PREAMBLE TO AMENDMENT TO MOTOR VEHICLE SAFETY STANDARD NO.201

Occupant Protection In Interior Impact—Passenger Cars

(Docket No. 19)

Figure 1—Test Fixture for Clamped Specimens

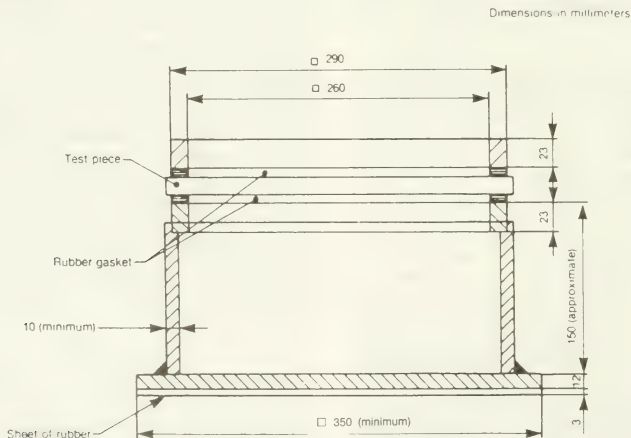
Figure 1 is added at the end of Federal Motor Vehicle Safety Standard No. 205.

(e) The glass-plastic glazing specimen tested in accordance with Test No. 26 shall be clamped in the test fixture in Figure 1 of this standard in the manner shown in that figure. The clamping gasket shall be made of rubber 3 millimeters (mm) thick of hardness 50 IRHD (International Rubber Hardness Degrees), plus or minus five degrees. Movement of the test specimen, measured after the test, shall not exceed 2 mm at any point along the inside periphery of the fixture. Movement of the test specimen beyond the 2 mm limit shall be considered an incomplete test, not a test failure. A specimen used in such an incomplete test shall not be retested.

Figure 4—USE OF CLEARANCE TEST BLOCK TO DETERMINE HAND ARM ACCESS

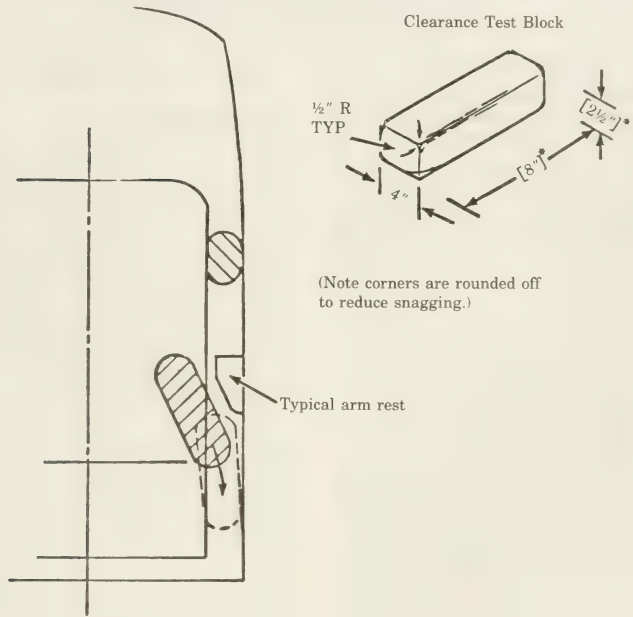
13. Figure 4 of this standard is modified as follows:
